Product Change Notification

1. ECR #: 207127
Notification #: 597

- EPLSP - EPLSP CABLE ASSEMBLY, EPLSP CONNECTOR

4. Part #'s Affected

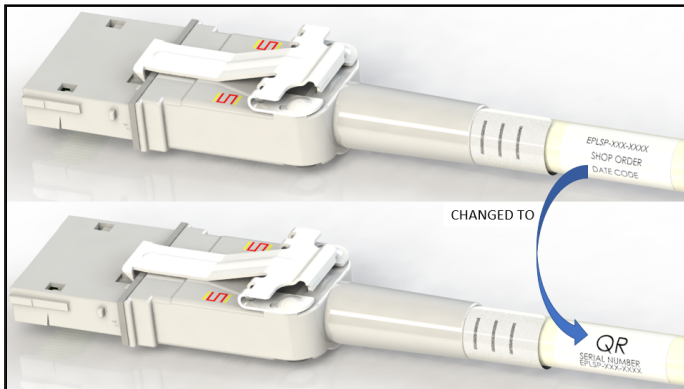
The label information on this cable assembly is being updated for improved tracking purposes. Currently, the label information consists of part number, shop order number, and date code. The updated label information will consist of a QR code, serial number, and part number.

The old label will show part number, shop order, and date code. The new label will show QR code, serial number, and part number.

The update to label information is shown here.

Currently:
EPLSP-XXX-XXXX
SHOP ORDER
DATE CODE

UPDATED:
QR CODE
SERIAL NUMBER
EPLSP-XXX-XXXX

The shop order and date code information are being replaced by a QR code and serial number.
